SERVICE INFORMATION LETTER

SERVICE INFORMATION LETTER NO. 0184

Revision 3

1. SUBJECT: Collective Trim Adjustment Rod Assembly, P/N 28-16242
2. MODEL: F-28C, F-28C-2, F-28C-2R, F-28F, F-28F-R, 280C, 280F, and 280FX
3. EFFECTIVITY: All S/N; excluding F-28F S/N 833 and subsequent and 280FX S/N 2164 and subsequent (see compliance note pertaining to other serial numbers)
4. BACKGROUND:

Figure 3. Collective Trim Adjustment Rod Assembly

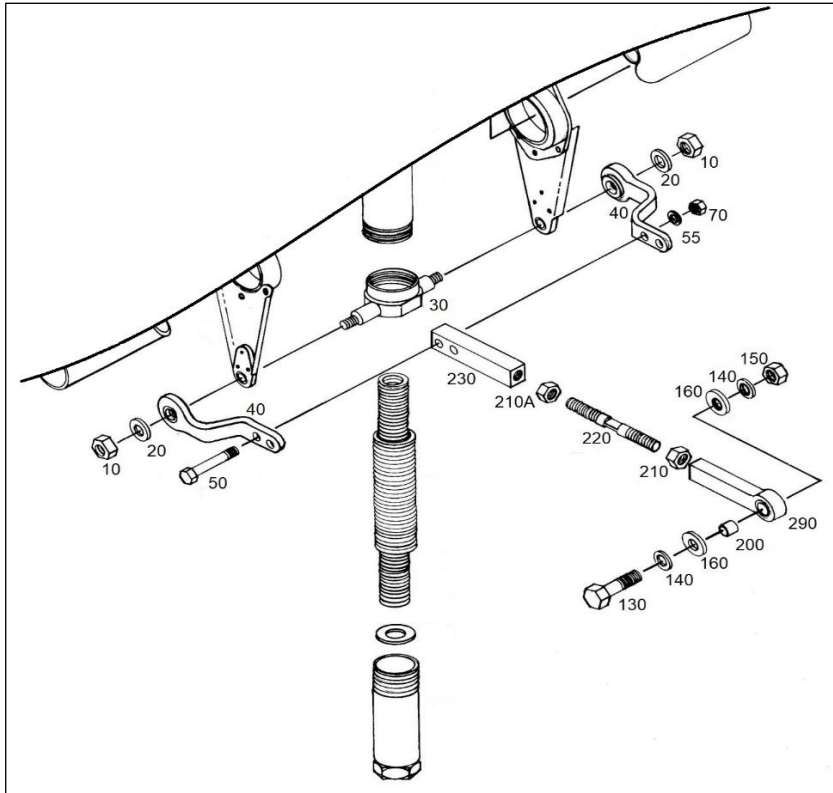
This SIL provides information regarding the installation of collective trim adjustment rod assembly P/N 28-16242-1 or collective trim adjustment rod assembly P/N 28-16242-7. Updates to this assembly allow greater adjustment of the collective trim capsule phasing which will simplify collective balance adjustment.

Revision 2 updates collective trim adjustment rod assembly P/N 28-16242-5 to P/N 28-16242-7 and kit P/N 28-16242-903 to P/N 28-16242-907.

- 6.5.1 Thread nuts (210 and 210A) on the tie rod (220). Note: Install appropriate left- or right-hand nut on the applicable left- or right-hand thread end of the tie rod.
- 6.5.2 Assemble links (230 and 290) and tie rod (220). Note: Link (290) is installed on left-hand thread end of the tie rod.
- 6.5.3 Install the tie rod assembly to the seat structure with bolt (130), washers (140, 160), spacer (200), and nut (150).
- 6.5.4 Install the brackets (40) to the pivot housing (30) with washers (20) and nuts (10) (torque 12-15 in-lb/1.4-1.7 Nm).
- 6.5.5 Attach the brackets (40) to the tie rod assembly with bolts (50), washers (55), and nuts (70) (torque 12-15 in-lb/1.4-1.7 Nm).

- 6.5.5.1 To align the link (230) and bracket (40) attachment holes, turn the tie rod left- and right-hand nuts (210 and 210A) in or out as required. (It may be helpful to use the length measured in step 6.4.1 to assist with a starting point for finishing the assembly.)
